BLUE BIRD

DATE: SEPTEMBER 14, 2015
TO: BLUE BIRD OWNERS
SUBJECT: RECALL R15YC
C E WHITE QUASI-STATIC GUSSET FASTENERS

IMPORTANT SAFETY RECALL NOTICE

NHTSA Recall Number 15V136 School Bus

Figure 1

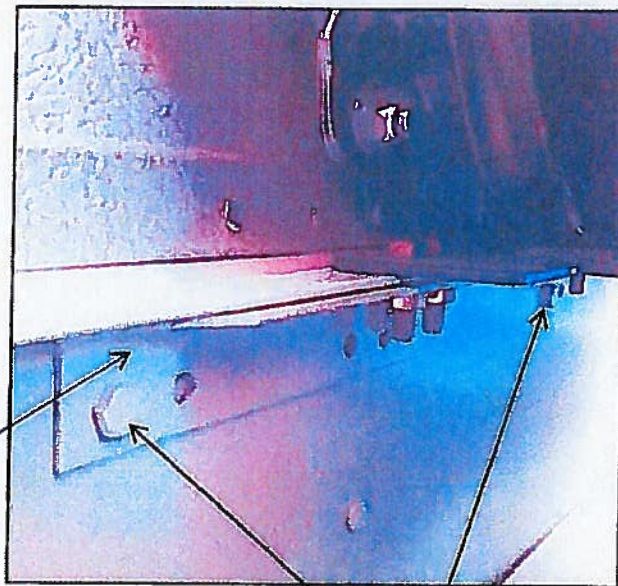
Locate the seat gusset reinforcement bracket for each Quasi-Static, 3-point seat. It will be fastened to the wall, immediately below the seat ledge, with at least two (2) grade 8 bolts. Visually check the bolts for six (6) dashed markings on the head of each bolt as referenced in Figure 1. If these markings are not present or there are other markings, perform the remaining instructions.

Figure 3

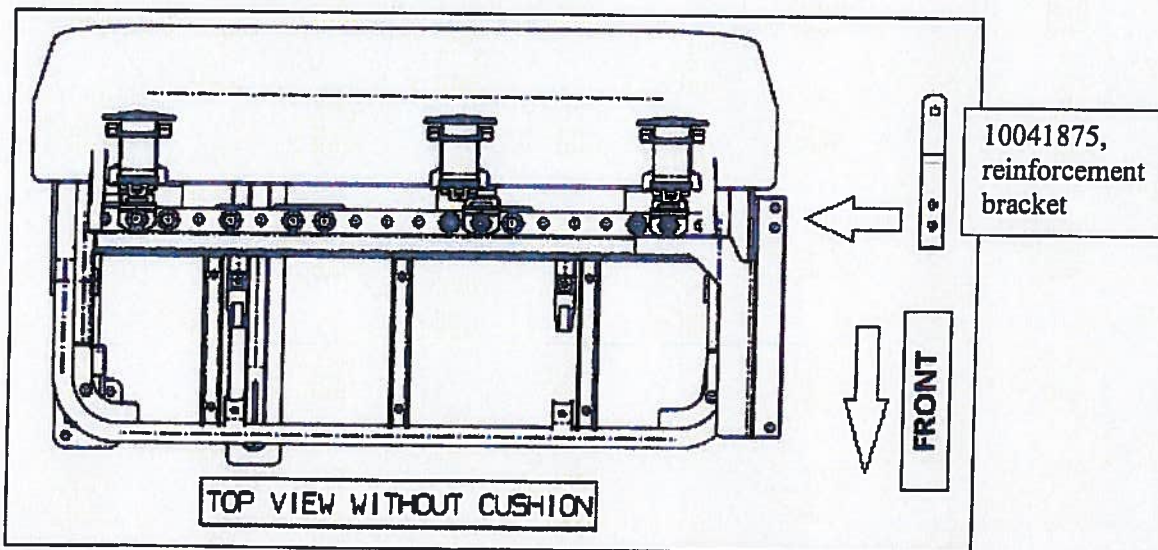
1. Remove and retain the two rear most mounting fasteners attaching the seat to the gusset. Reference Figure 2 for location of the two fasteners.
2. Place the new reinforcement bracket (10041875) into position and reinstall the two fasteners. Reference Figure 3 and Figure 4 for bracket location. Tighten fasteners snugly but do not torque.
3. Using a 25/64" drill bit (obtain locally), locate the rear hole on reinforcement bracket 10041875. Using this hole as a guide, drill thru the gusset and lower seat gusset reinforcement bracket.
4. Clean away metal shavings and install new 3/8" capscrew (00803213) and nut (02171809). Reference Figure 4 for an installed reinforcement bracket.
5. Torque new 3/8" nut (02171809) to 29-33 ft. lbs.
6. Torque two (2) existing 5/16" nut(s) to 12-13 ft. lbs.

Photo # 1

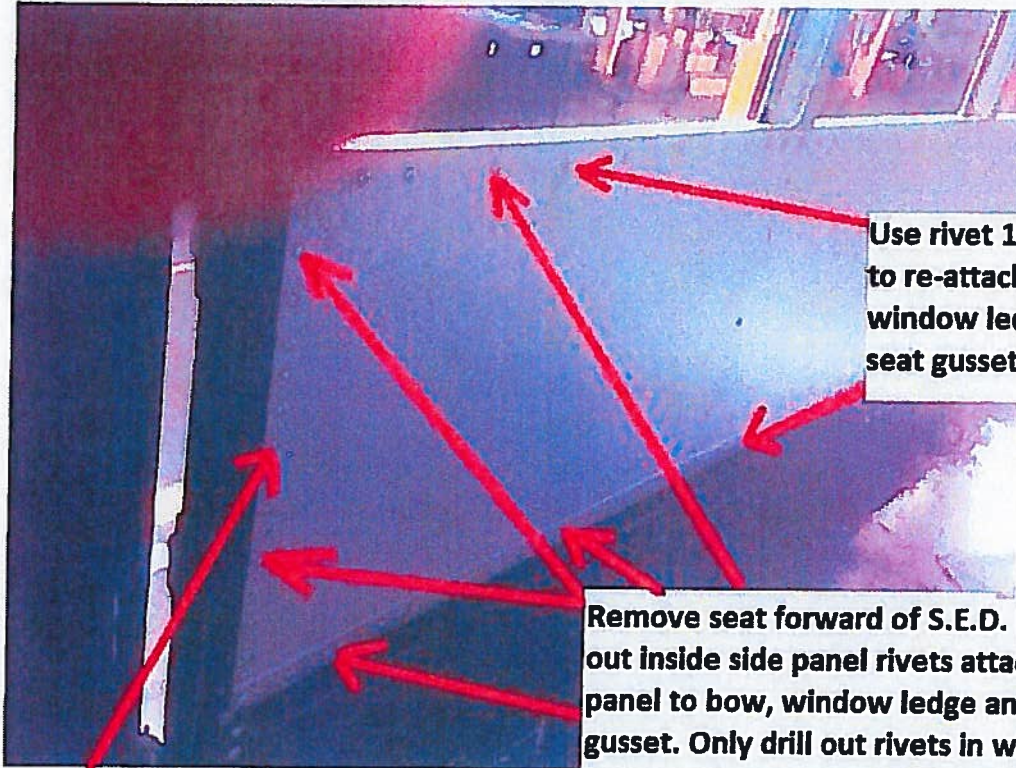
- Remove passenger seat just forward of S.E.D.
- Remove passenger window retainer screw/washer at S.E.D.
- Drill out inside side panel attaching rivets at door, window ledge and seat gusset (see Photo # 1).

- Torque 3/8 bolts to 29-33 ft. lbs.
- Clean old adhesive from inside side panel, window ledge, seat gusset and apply Magnobond adhesive (10016411) to panel and reinstall with correct rivets per photo # 1 instruction. **No adhesive required at panel to S.E.D. bow vertical joint.**

Use rivet 10034534 to re-attach panel at window ledge and seat gusset.

Remove seat forward of S.E.D. Drill out inside side panel rivets attaching panel to bow, window ledge and seat gusset. Only drill out rivets in window ledge and seat gusset 12"-18" forward of S.E.D. Peel back inside panel to gain access to back side of seat gusset.

Use rivet 01549211 to re-attach panel to S.E.D. bow.
